DRAFT
Environmental Impact Statement

Appendix 17B

Supplemental PCN Information

The Belleayre Resort at Catskill Park

Wetland Edges

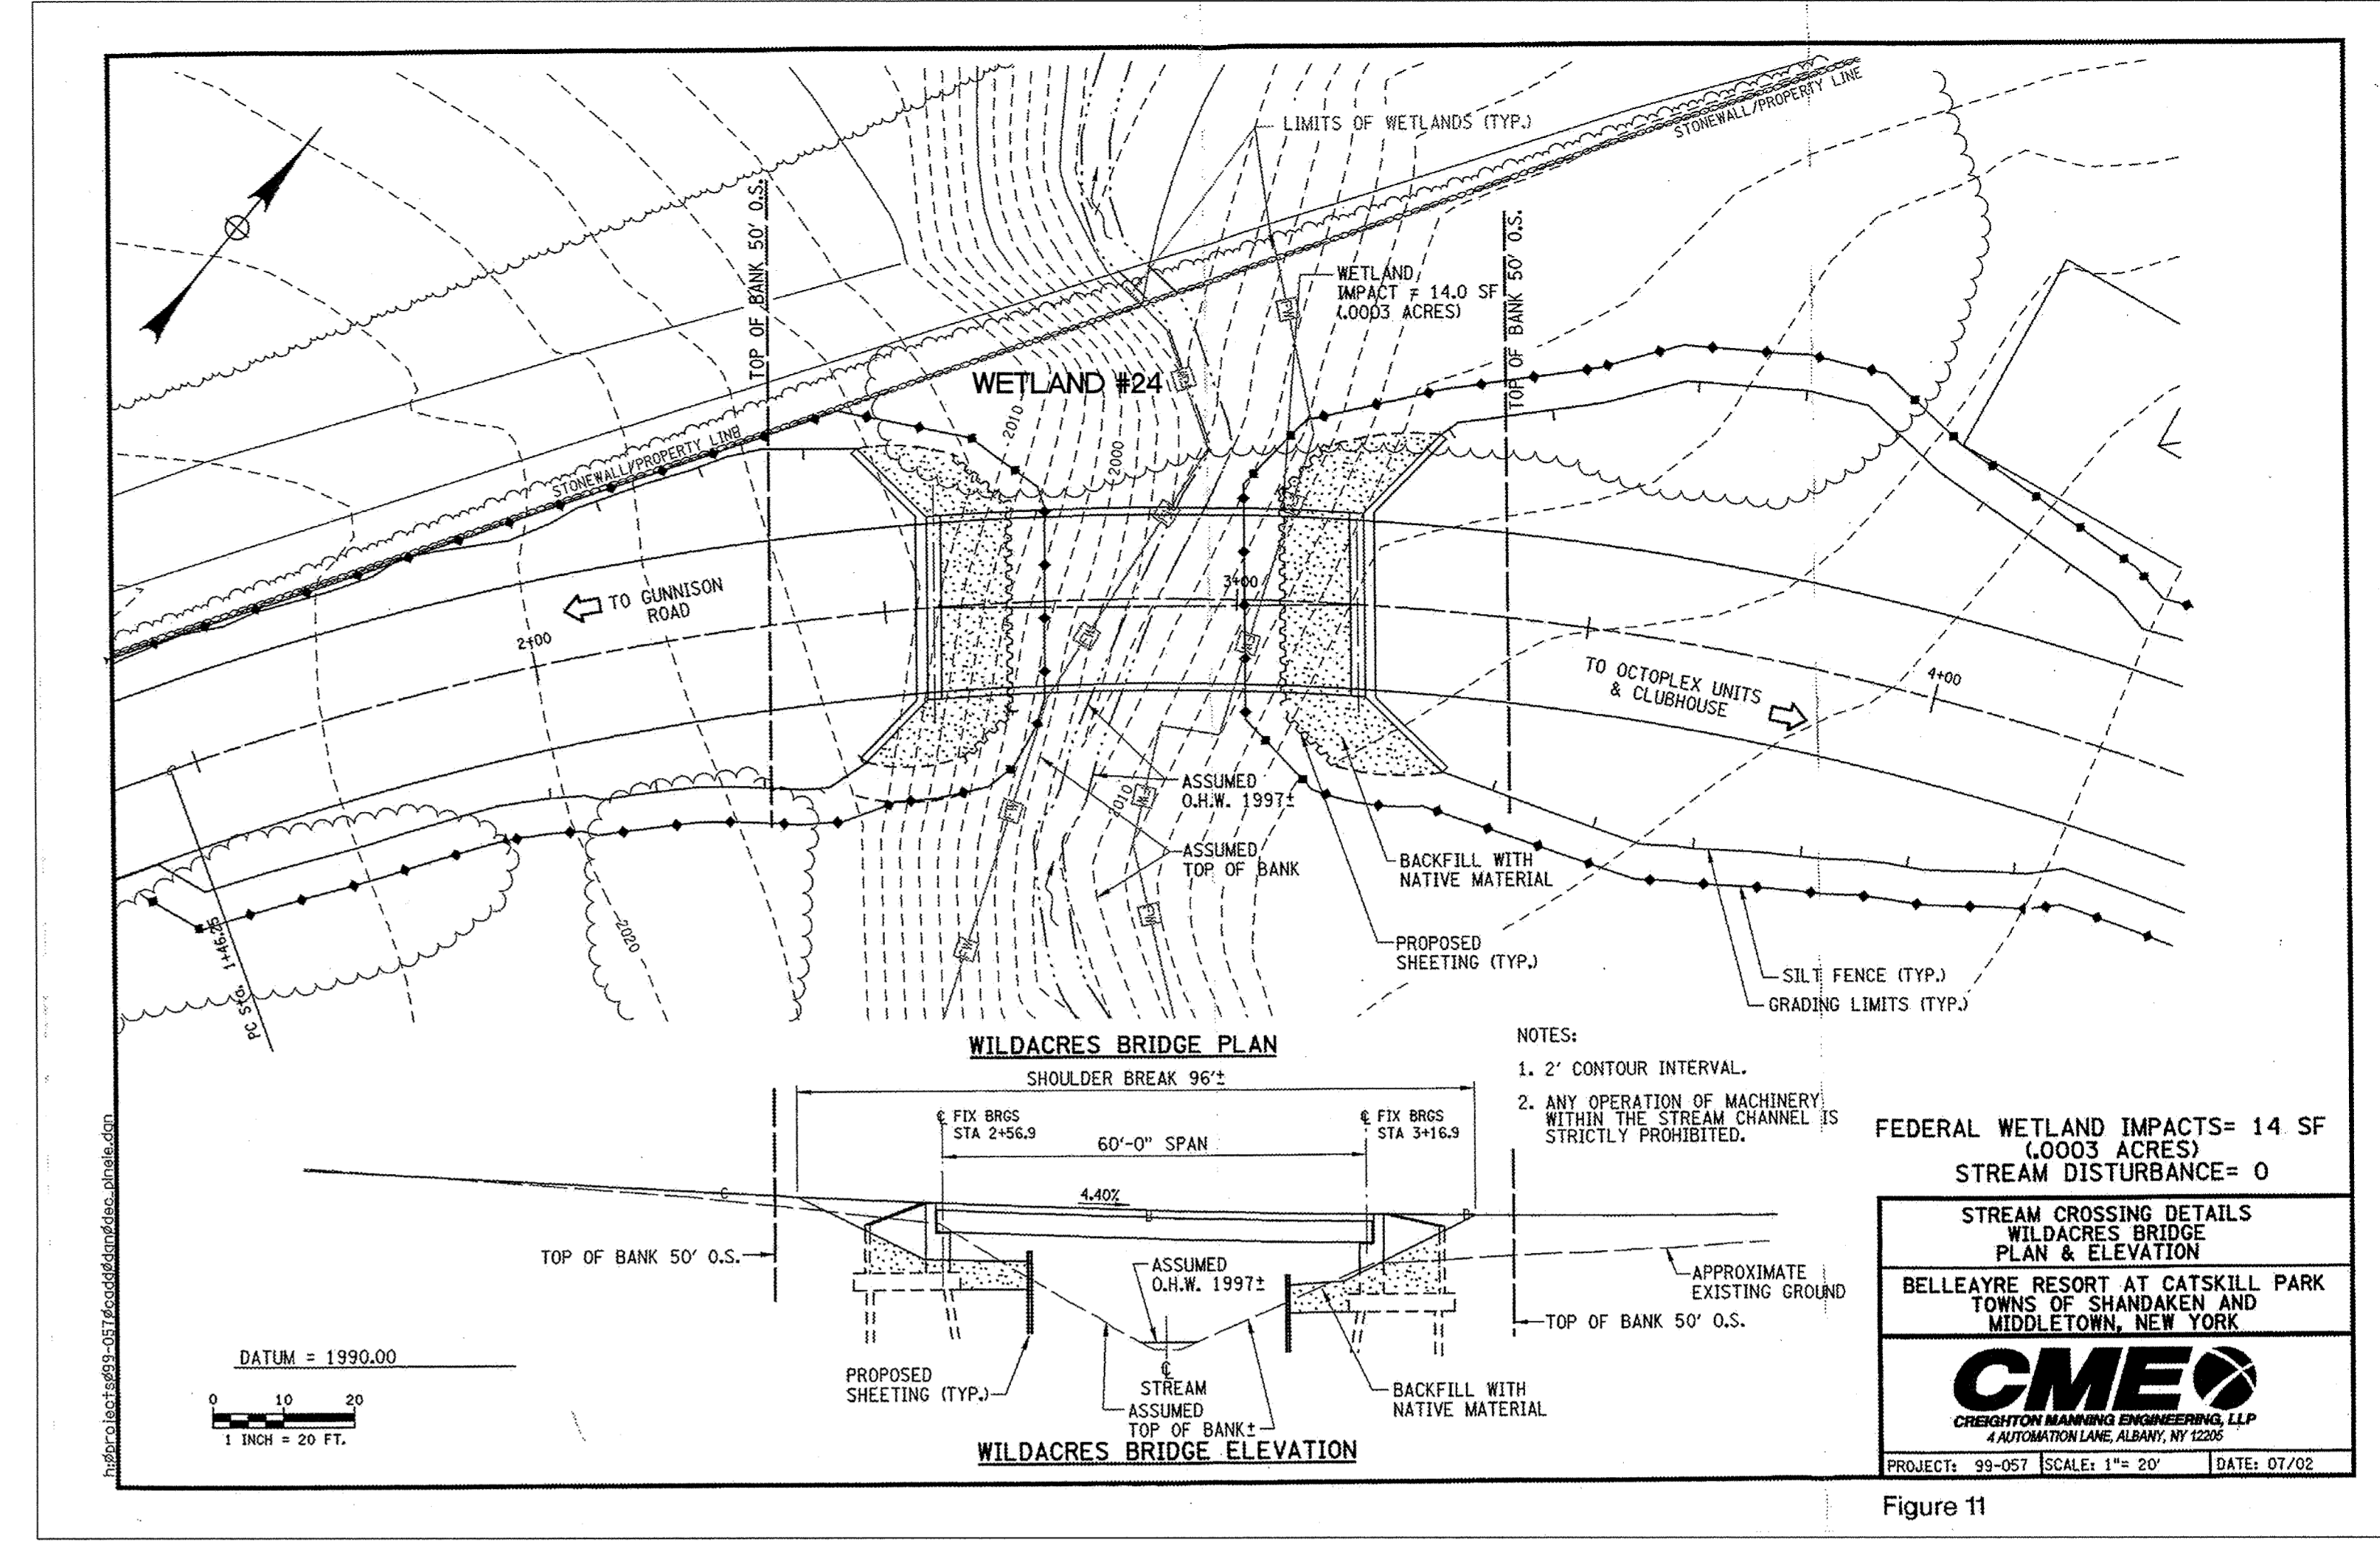
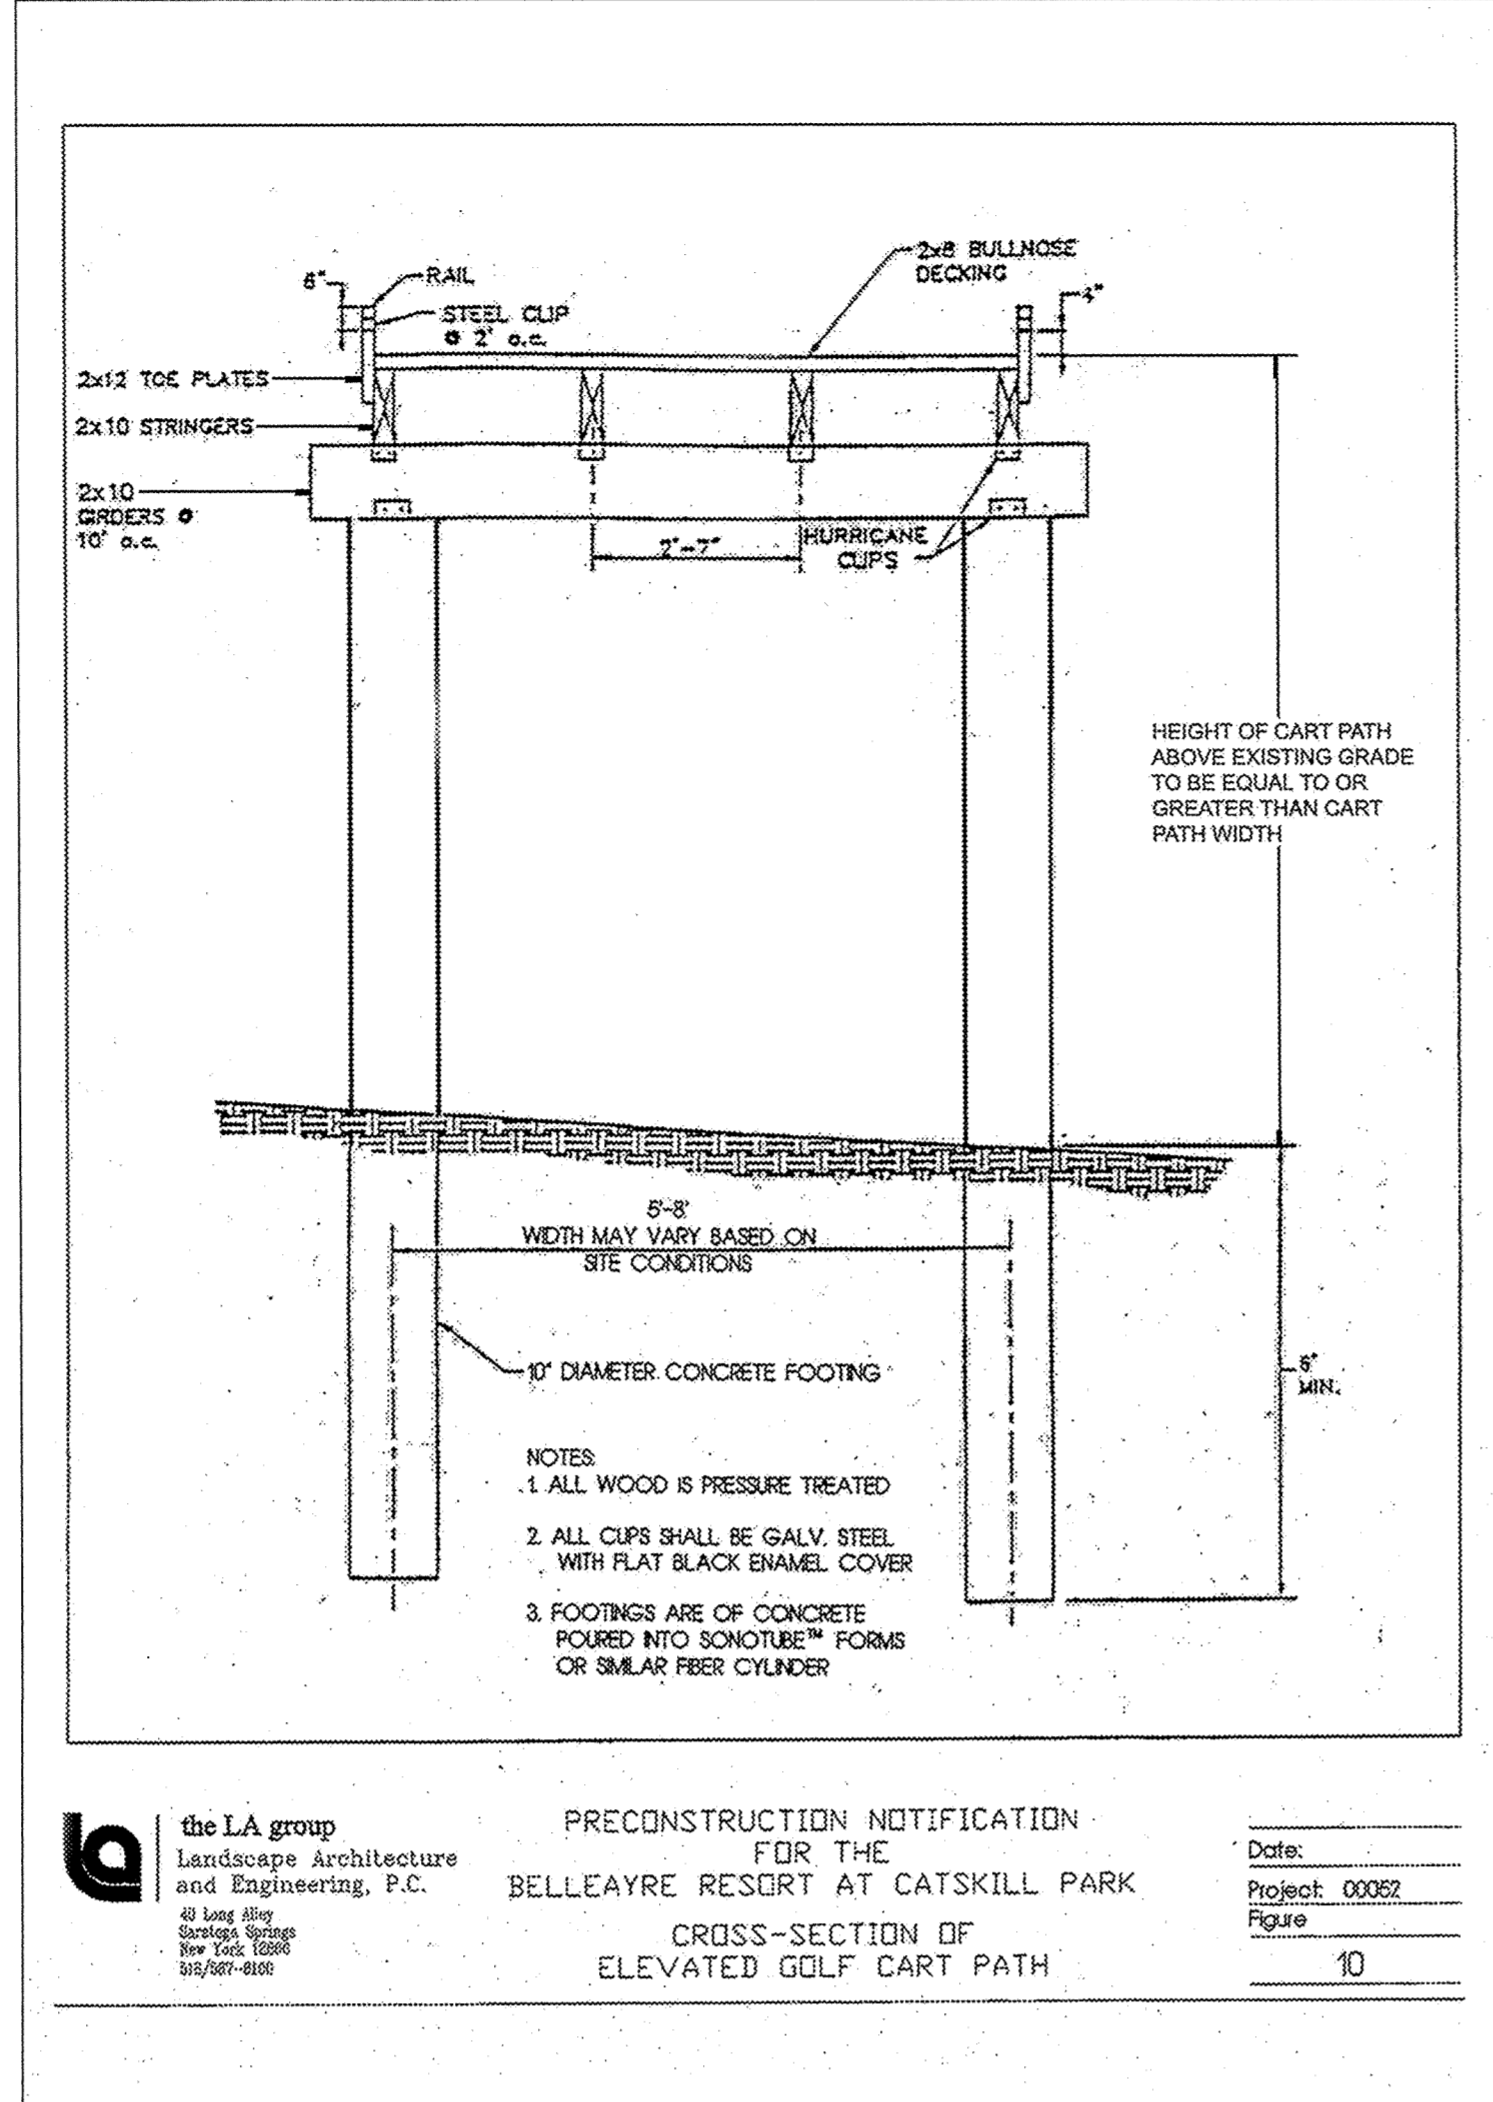
The tree clearing protocols from Exhibit 6 have been revised and a copy is included on Detail Sheet D-1. The revisions deleted the alternative removal method that involved winching. This method is no longer proposed.

A revised Figure 10 has also been added to Detail Sheet D-1. The revision to this figure shows a cart path with a deck higher above existing grade. A note has also been added stating that the deck height above grade is to be equal or greater than the deck width. The great majority of the proposed decking will be 5 feet wide, but there will be some short

Figure 11 has been added to Detail Sheet D-1.

Figures 12 and 13 have been added to Detail Sheet D-1.

Figure 15

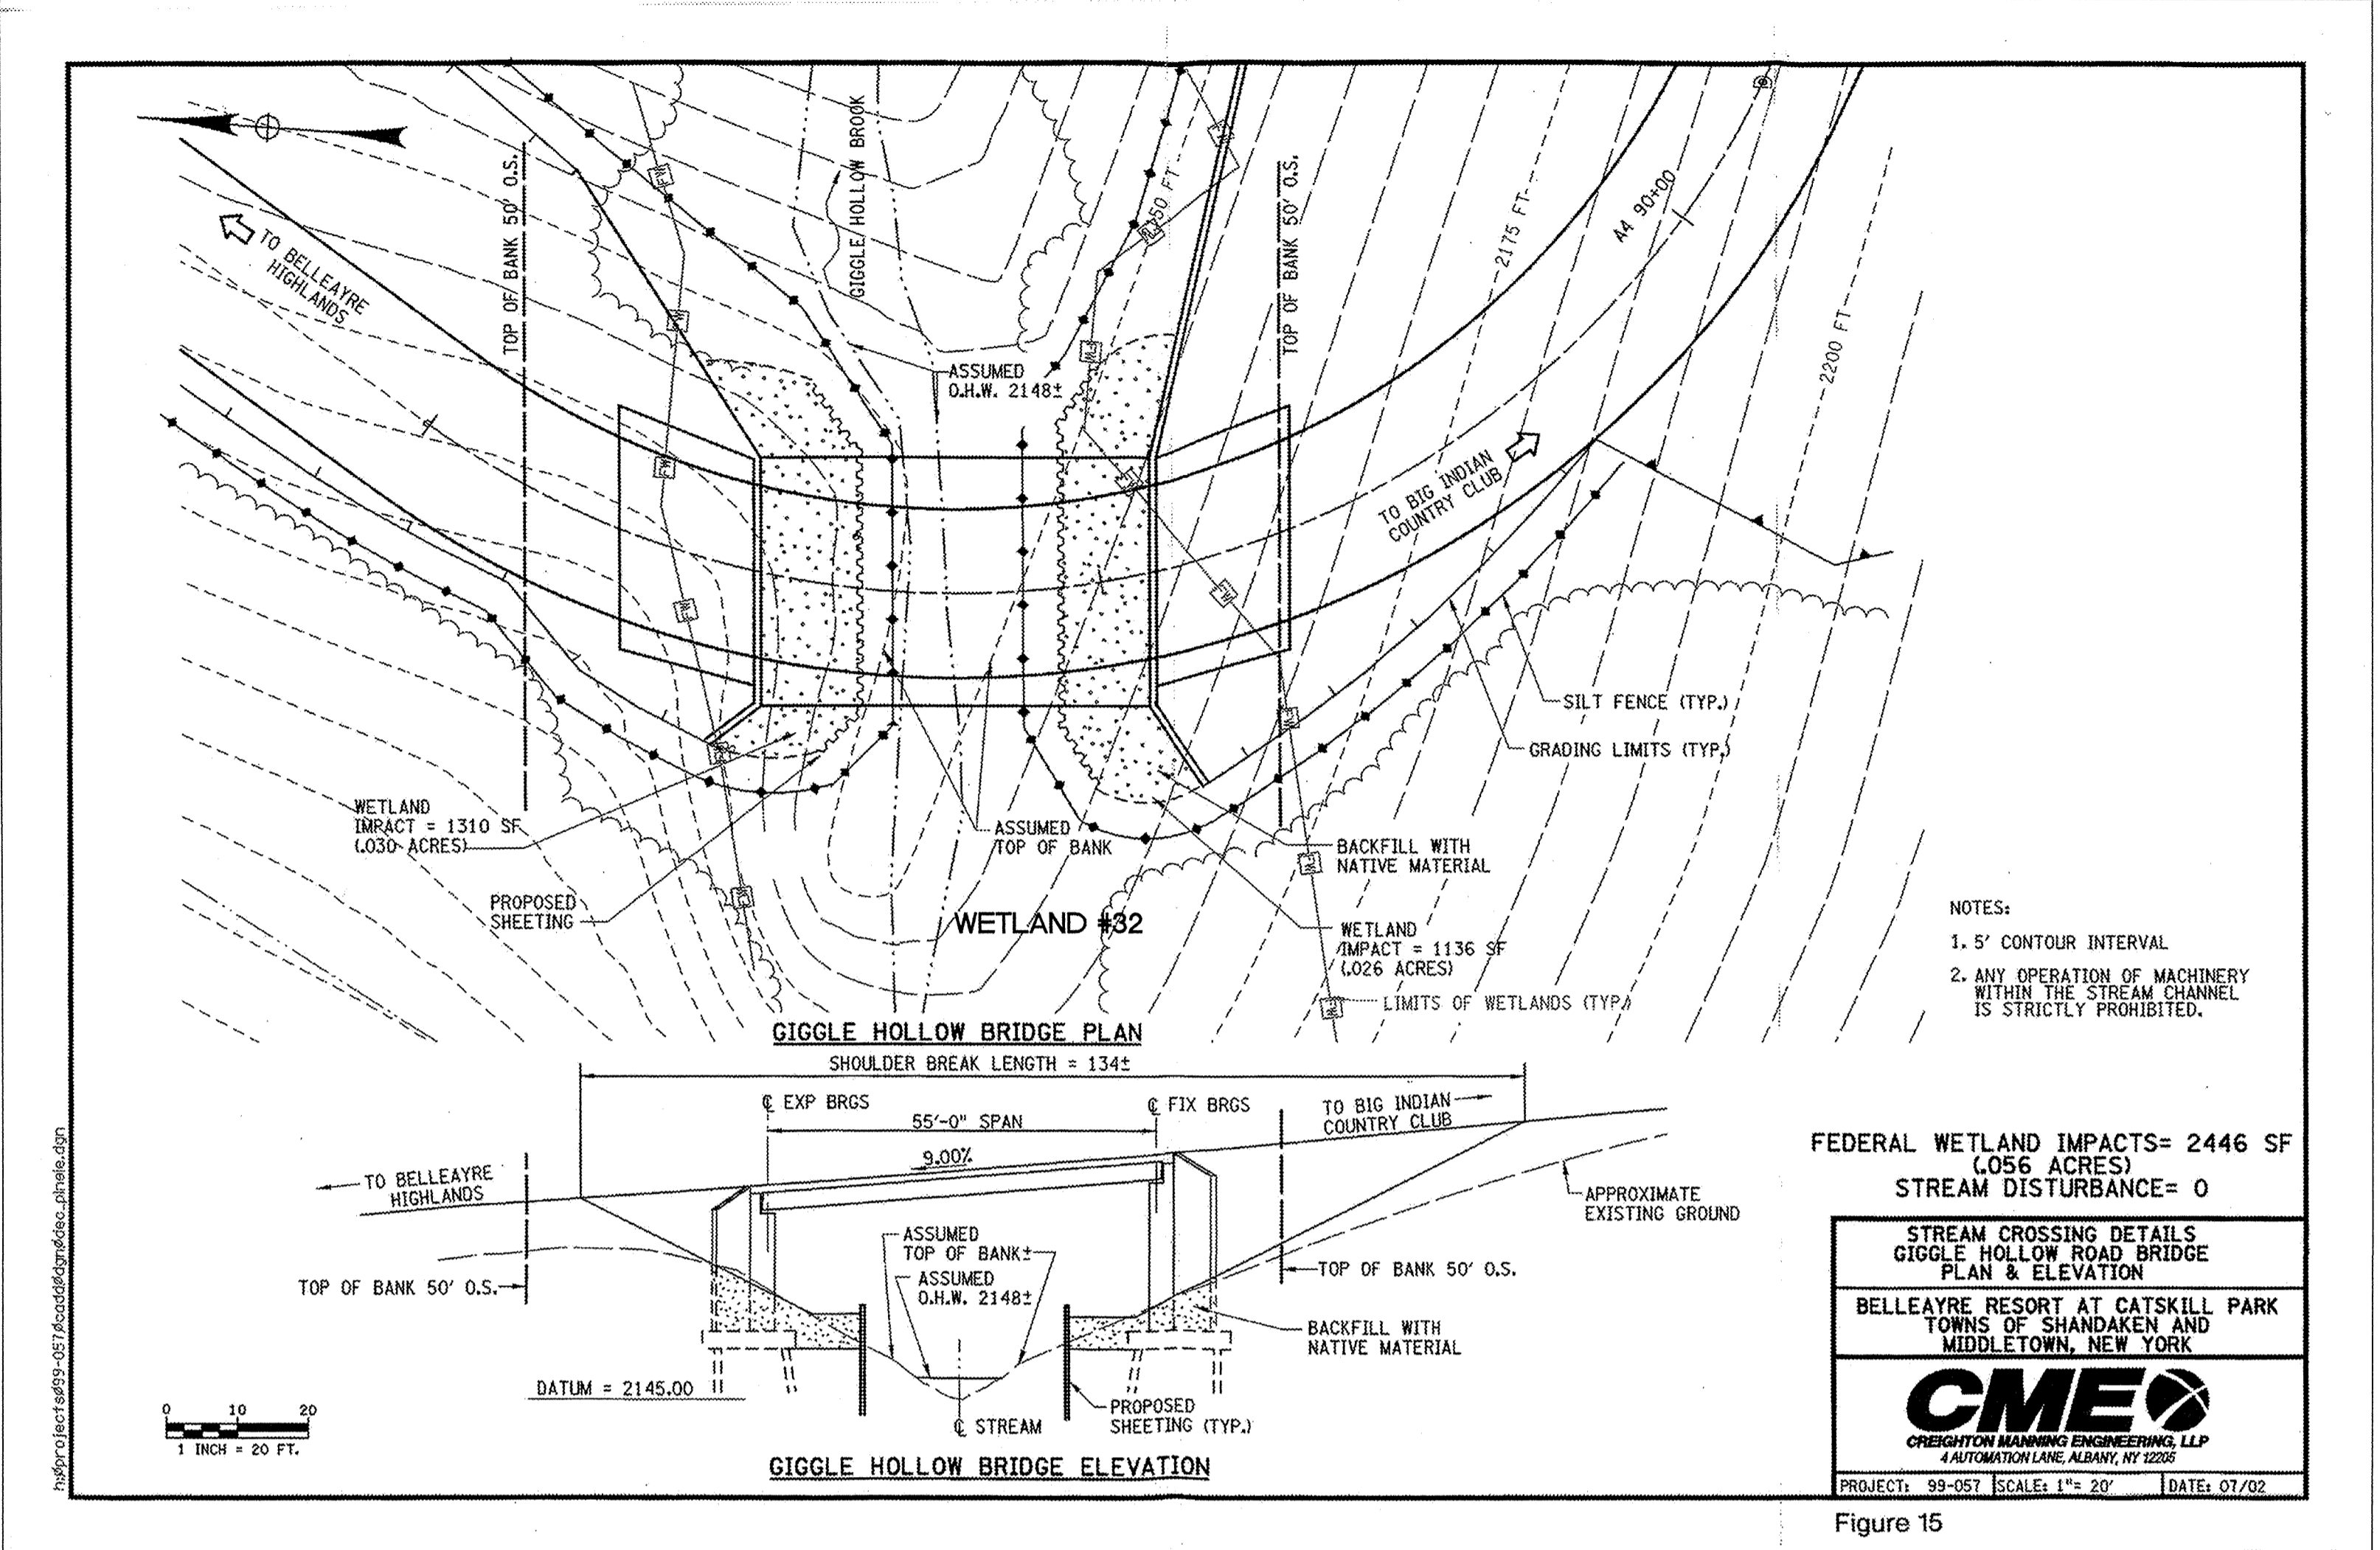
Figure 15 has been added to Detail Sheet D-2.
